Access Compliance Report

Public Rights-of-Way

Intersection ID: 19204	Main Street: CHARTER_PL	Cross Street: ROCKY_FALLS_RD	Location: W
ADA ID: 07F673BE6DBC	Ramp Type: BlendTrans2	Initial Pass/Fail: Fail	Overall Compliance: No
Severity Score: 36.25			
Codes/Mitigation Info/Possible Solution		Field Measurements/Component Compliance

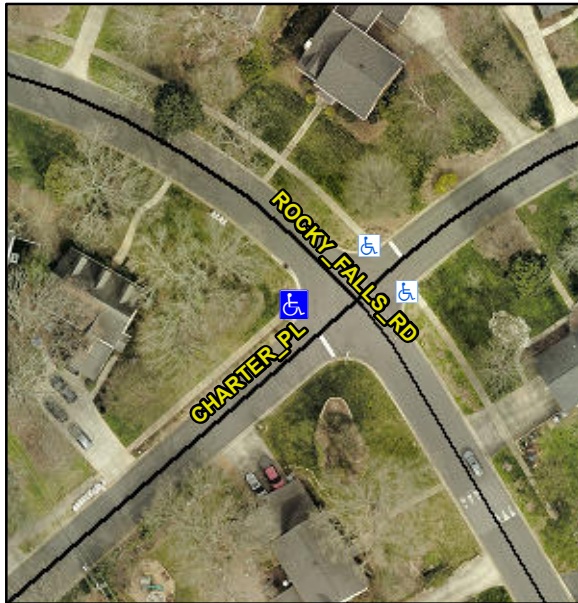
Not Found, R304.5.1, R304.5.3

Compliance	Description	Data	Compliance	Description	Data
N/A	Ramp Length (in)	96.0	Yes	BlendTrans Slope (%)	2.2
No	Ramp Width (in)	30.0	No	BlendTrans XSlope (%)	2.3
N/A	Flare Type LT	N/A	N/A	Flare Type RT	N/A
N/A	Flare Slope LT (%)	N/A	N/A	Flare Slope RT (%)	N/A
N/A	Flare Traversable LT?	N/A	N/A	Flare Traversable RT?	N/A
N/A	Landing Length (in)	N/A	N/A	DWS Provided?	N/A
N/A	Landing Width (in)	N/A	N/A	DWS Contrast?	N/A
N/A	Landing Slope (%)	N/A	N/A	DWS Length (in)	N/A
N/A	Landing X Slope (%)	N/A	N/A	DWS Full Width?	N/A
N/A	Landing Curb? (Y/N)	N/A	N/A	DWS Offset (in)	N/A
N/A	Shared Landing?	N/A			
N/A	Gutter Ponding?	N/A	N/A	Gutter Slope (%)	N/A
N/A	Gutter Lip Ht (in)	N/A	N/A	Gutter X Slope (%)	N/A
N/A	Painted X Walk1?	No	N/A	Painted X Walk2?	No
	X Walk 1 Direction	To SE		X Walk 2 Direction	To NE
	X Walk 1 Width (in)	N/A		X Walk 2 Width (in)	N/A
	X Walk 1 Slope (%)	2.2		X Walk 2 Slope (%)	1.5
	X Walk 1 X Slope (%)	1.7		X Walk 2 X Slope (%)	1.3

N/A	Ramp inside XWalk1?	N/A	N/A	Ramp inside XWalk2?	N/A
	Road Slope (%)	1.1		Clear Space?	N/A
	Road X Slope (%)	0.7	N/A	Clear Space to XWalk (in)	N/A
N/A	Any Obstructions?	N/A	N/A	Storm Grate/Utility Hazard?	N/A
	Obstruction Type			Storm Grate/Utility Type	
		N/A			N/A
			Yes	Surface Condition? (G/P)	Good
			No	Curb Slope (%)	9.1

Remove & Replace Curb Ramp With Two New Directional Ramps or Equivalent.
